Staff Report

Infill Housing Design Review Committee

File Number: 3-E-21-IH

Location: 3333 Johnston St. **Parcel ID** 81 H C 042
Zoning: RN-2 (Single-Family Residential Neighborhood)
District: Lonsdale Infill Housing Overlay District

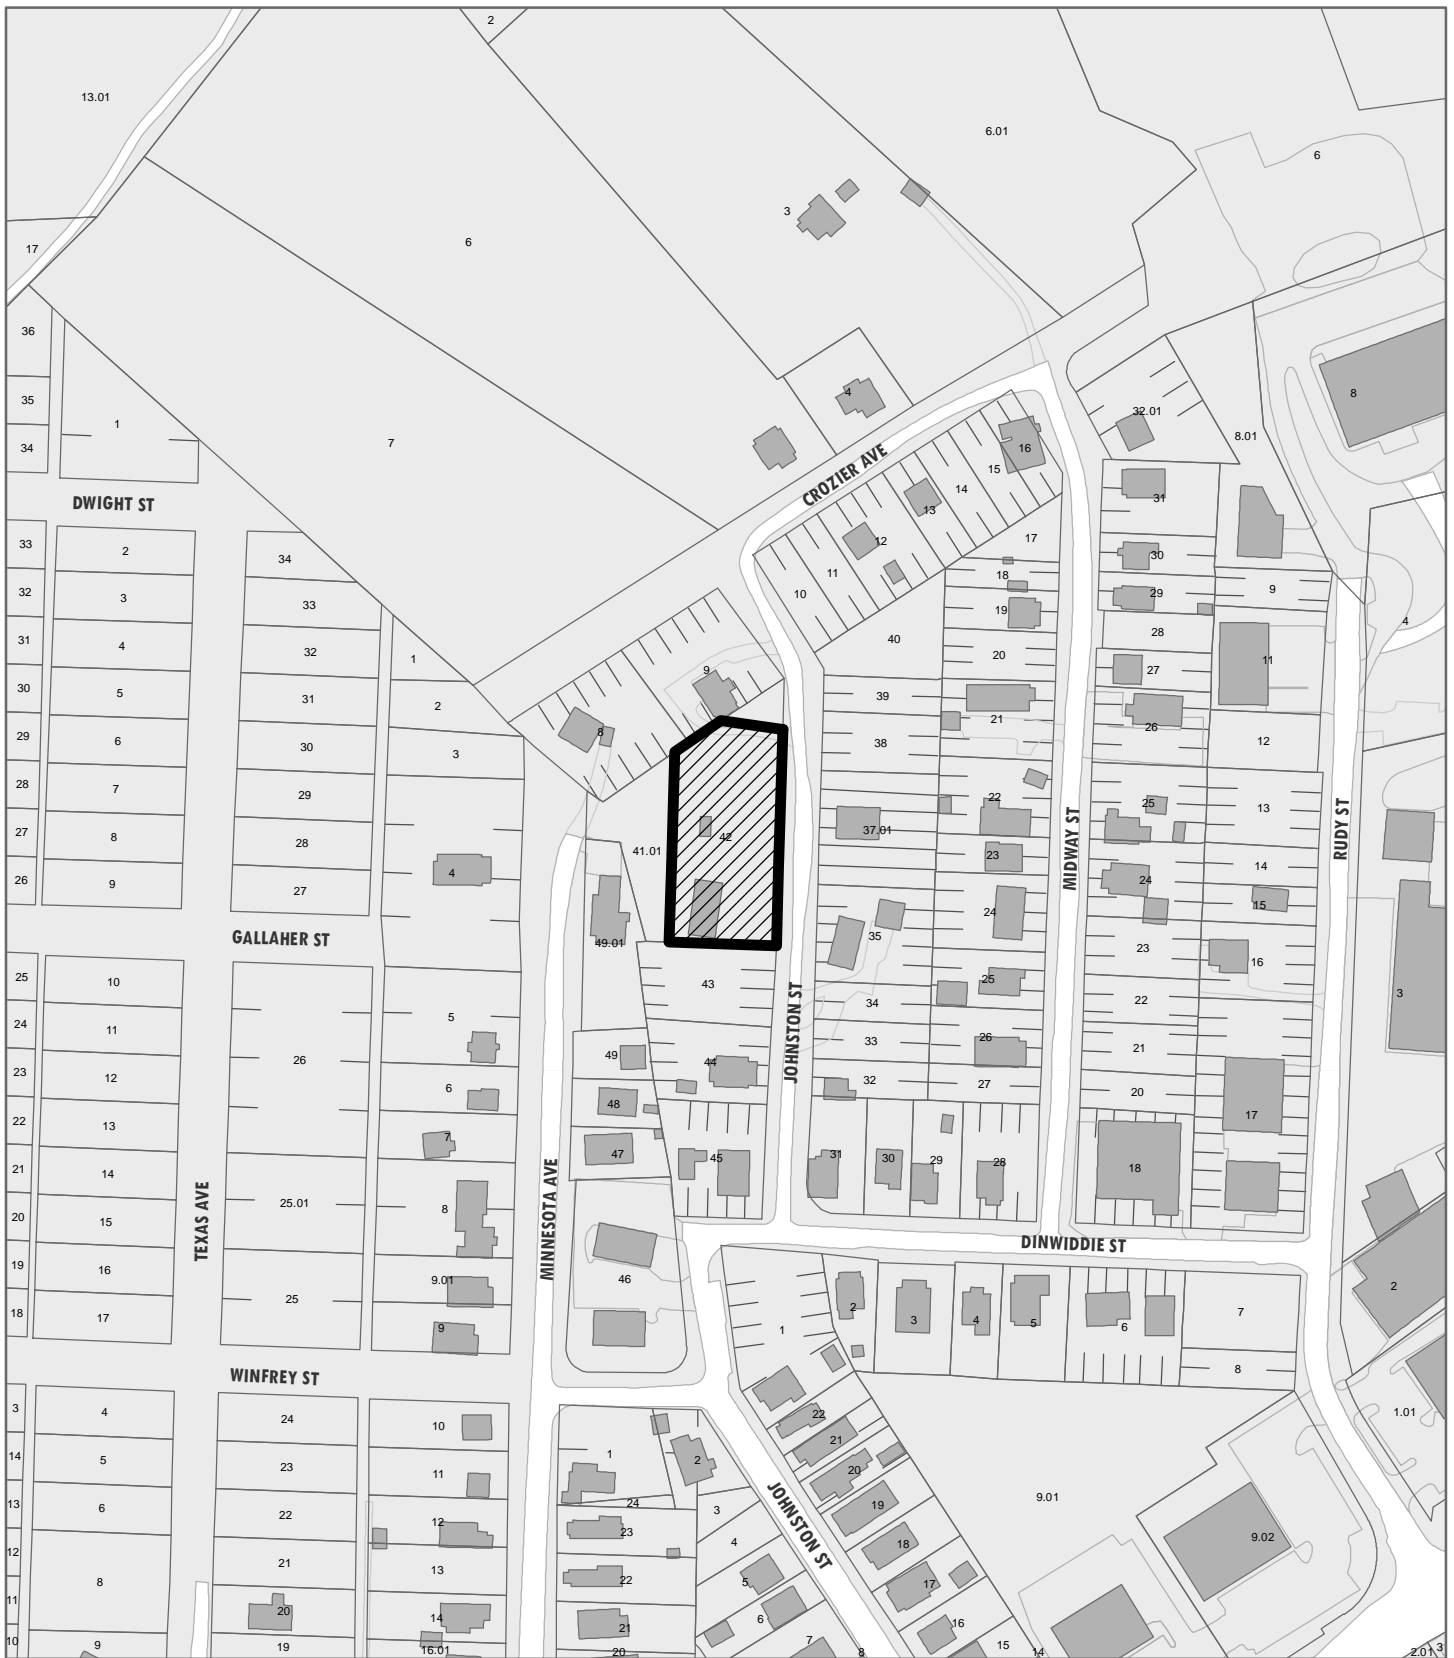
1. The house is proposed to be sited in the rear left (southwest) corner of the lot. The lot is uniquely large and

shaped, measuring 223' long on the Johnston Street (front) elevation and approximately 115' deep. The house is proposed to be set 60.55' from the front property line, 11.78' from the left (south) property line, and approximately 135' from the right (north) property line.

3311 Johnston St is set approximately 20' from the main massing to the front property line. Across the street, 3334, 3314, and 3310 Johnston are all in the range of 15'-30' from the property line. While the block does not have as consistent a streetscape pattern as adjacent Minnesota Avenue or Midway Street, setting the house in a rear corner at 61' from the front property line will further create an irregular front yard pattern. The site plan does not include a walkway from the sidewalk or street to the front door.

2. The new house is not proportional to the dimensions of the lot or other historic houses on the block. The existing block does not retain a large deal of historic structures from which to draw context; several of the houses are modern infill which were constructed prior to the Infill Housing overlay. The proposed side yard setbacks are not compatible with the context; the rhythm of spacing between houses is not consistent.

3. Parking is proposed for the front yard, which is discouraged in design guidelines. Guidelines also note that garages or parking pad should be at least 20' behind the front façade of the infill house. There is no proposed landscaping or fencing.

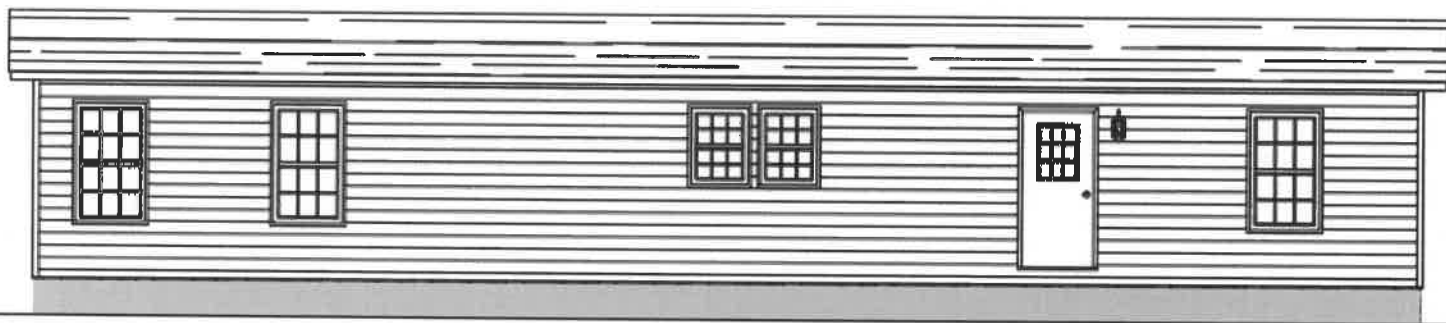
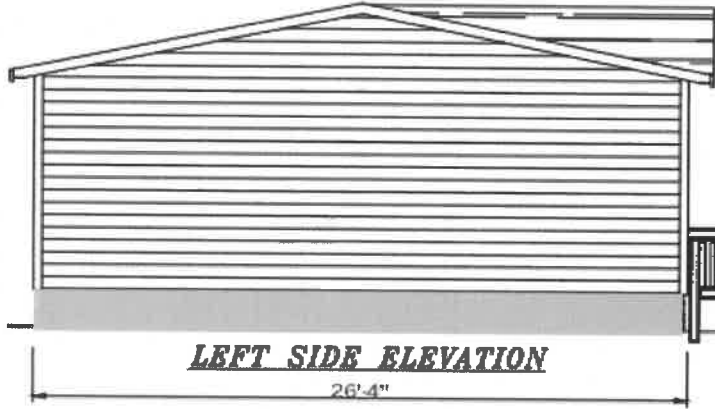
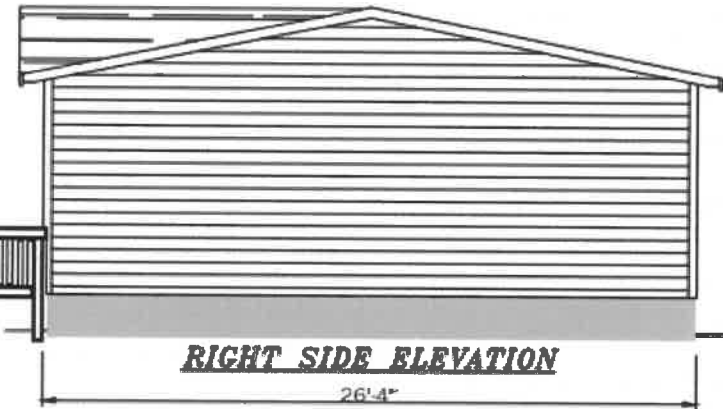
4. The proposed house is not similar in scale or massing to the surrounding context; the house is a Ranch-style house which is significantly wider than original houses in the neighborhood. The house does not include extensions or bays.

5. The house does not incorporate a porch proportional to original houses in the neighborhood. There are three steps leading up to the doorway, which does not qualify as a stoop.

6. While the provided rendering shows one-over-one windows, the elevation drawing shows six-over-six vinyl windows. Six-over-six windows are generally not considered appropriate for a historic context. There are no windows on the side elevations ("attention should be paid to window placement and the ratio of solid to void").

7. The roof has a 3/12 pitch, which is lower than any historic houses on the block. The minimum pitch approved by the board has generally been 6/12.

8. The proposed vinyl siding, stuccoed foundation, and asphalt shingle roof does meet the design guidelines; however, the vinyl Dutch lap siding is commonly discouraged in Infill Housing reviews. Lap siding with an overlap to resemble wood clapboard siding would be more appropriate.

Staff recommends denial without prejudice of Certificate 3-E-21-IH, due to the proposal not meeting the Infill Housing design guidelines. If the Board chooses to approve Certificate 3-E-21-IH, approval should be conditioned on a steeper roof pitch (6/12 or above), the addition of a porch to meet design guidelines, the use of lap siding instead of Dutch lap, the addition of windows on side elevations, the revision of parking placement to meet design guidelines, and revision of site plan to provide front and side setbacks more consistent with the context.
